TECHNICAL EVALUATION REPORT  
R. E. GINNA NUCLEAR POWER PLANT  
STATION BLACKOUT EVALUATION

Final  
October 30, 1991

U.S. Nuclear Regulatory Commission  
Washington, D.C. 20555

Contract NRC-03-87-029  
Task Order No. 38

Figure 1  
Electrical Distribution System

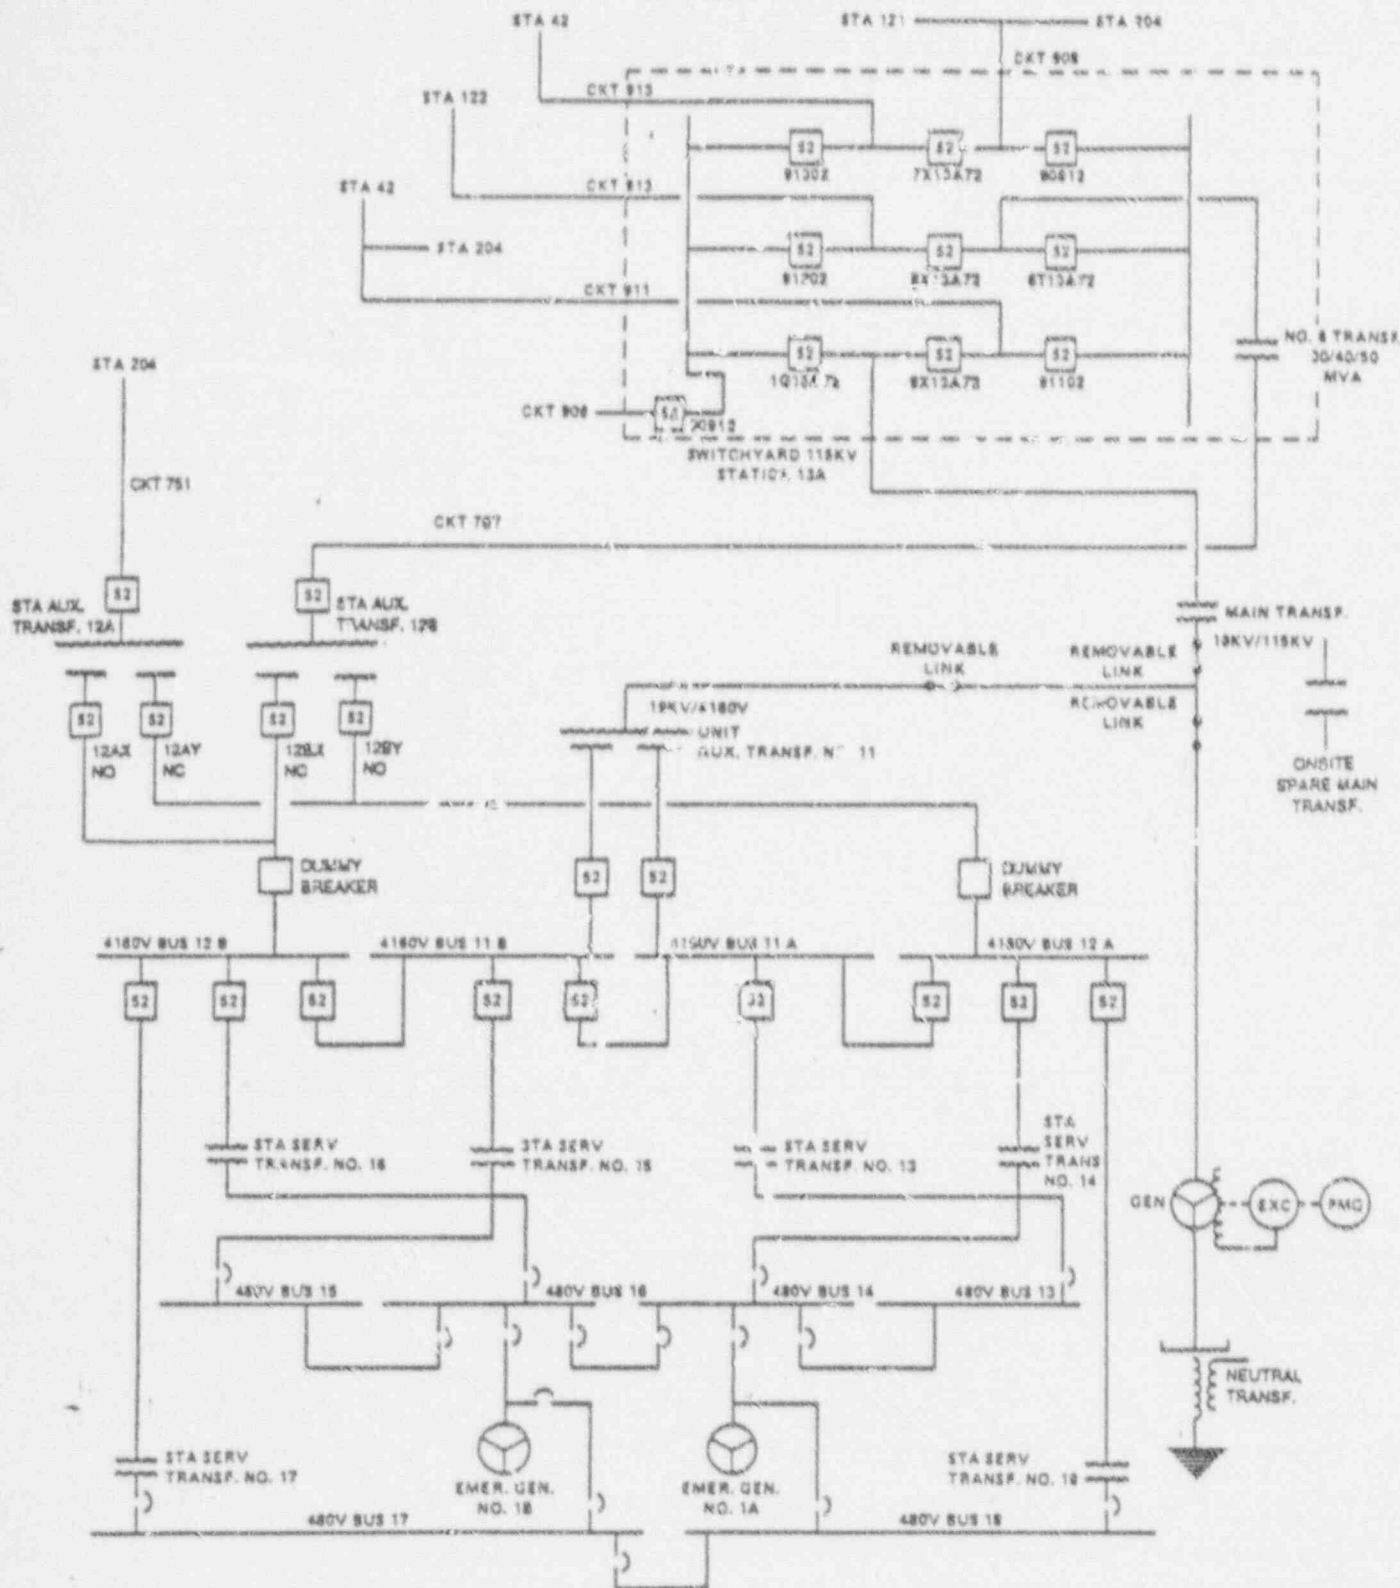
The licensee classified the independence of the plant offsite power system as "1 1/2." Our review of the plant UFSAR indicates (16) that (see Figure 1):

1. All offsite power sources are connected to the plant through electrically connected switchyards,
2. The safeguard buses are normally powered from two offsite power sources through Station Auxiliary Transformers (SATs) 12A and 12B, (each division of safeguard buses is powered from one SAT),
3. Each SAT is sized to accept all plant auxiliary loads for full power operation, and
4. Upon loss of power from one SAT, the connected safeguard buses can be powered from the other SAT through manual transfer.

Based on the above and the criteria given in RG 1.155, Table 5, the Ginna offsite power characteristics is classified as "I2."
